## The Details – Specific New Rule Language

### Mainsheet – Amends Rule 6.3 in Running Rigging Section

Diagram D. Aft split tail, aft bridle mainsheet arrangement attached to aft pad eyes

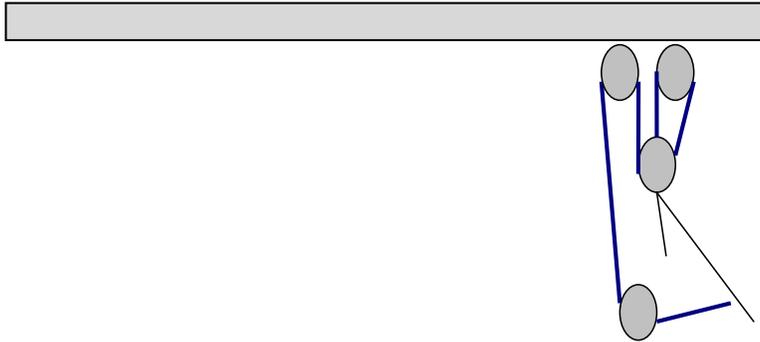
6.3.1 The mainsheet system shall be one of the following ~~three~~ four alternatives:

D. A split tail mainsheet where the split ends and a bridle with a turning point are attached to the aft pad eyes and shall include 5 turning points as per Diagram D.

6.3.2 In all ~~three~~ four alternative systems, the mainsheet must run through a turning point attached to a ~~mid~~ bridle. The bridle may be of any length, but may not be adjustable while racing. The bridle must be attached to the two mid bridle or aft bridle pad eyes installed by the builder. The mainsheet must also pass through at least one turning point located mid-boom, with mid-boom defined as the center of the attachment point and located within a range of between 1400 mm to 1750 mm as measured aft from the forward face of the boom.

6.3.4 A cockpit swivel cam base with turning point and cleat as located by the builder must be part of the mainsheet system. If alternative 6.3.1(D) is rigged on a boat, the mainsheet must be trimmed through the swivel cam's turning point while sailing to windward. The swivel cam base may be raised up to 5 cm above the cockpit floor. Any manufacturer's blocks, ferrules or rings may be used as turning points as long as they are no smaller than 40 mm or larger than 60 mm in outside diameter, except that the small sheave in a fiddle block, if used instead of 2 mid boom turning points, may be smaller than 40 mm. Only one turning point in the system may be a ratchet block and that ratchet block may be placed anywhere in the system. The mainsheet may only be cleated at the swivel cam base.
